# Addendum No. 5

Project: M-CON PHASE 2 & 4 EXTENSIONS (2460 Carp Road)

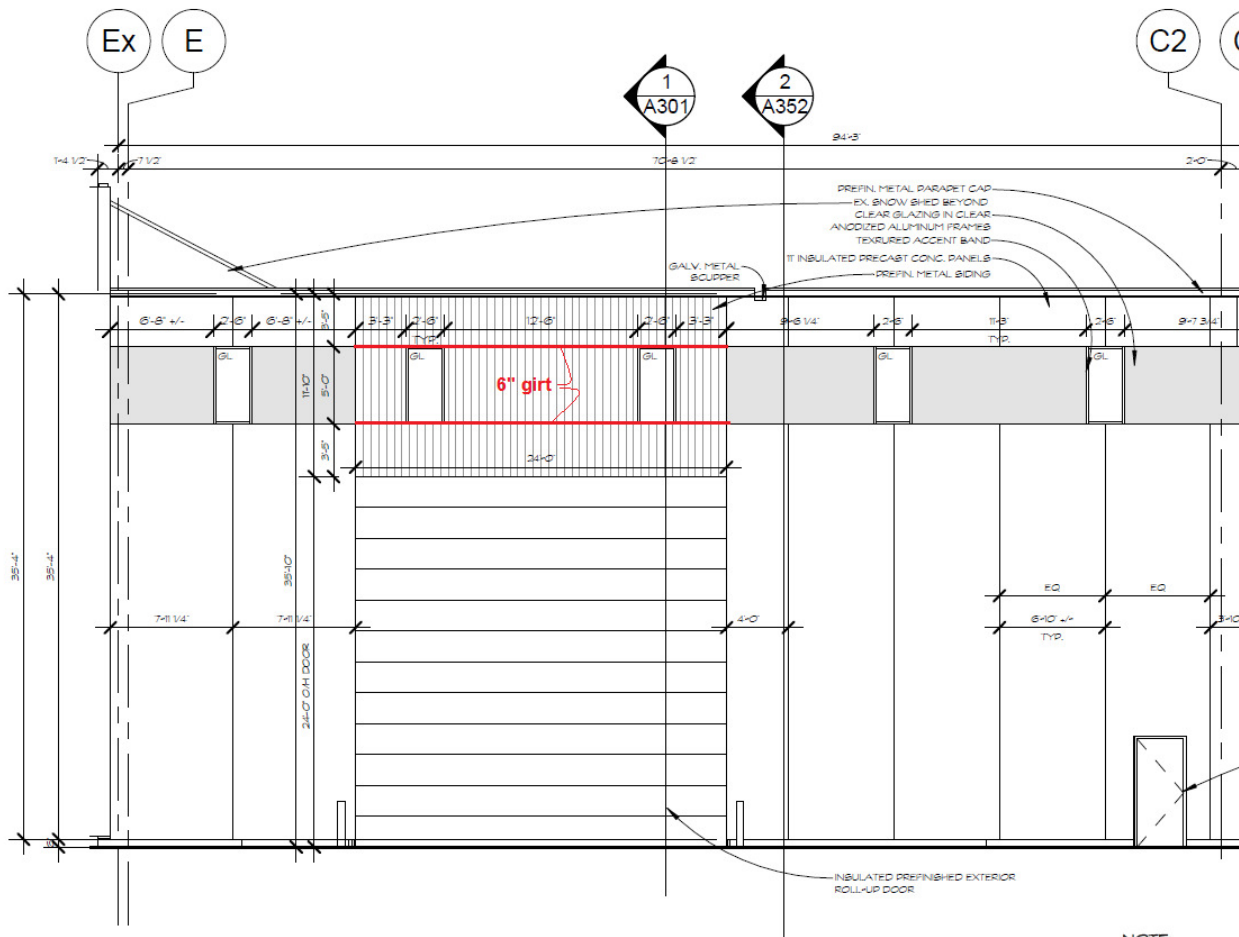
- 5.1 Metal fabricator to provide (2) 6" deep structural intermediate infill girts above both overhead doors to support windows. (refer to sketch – typical of both)
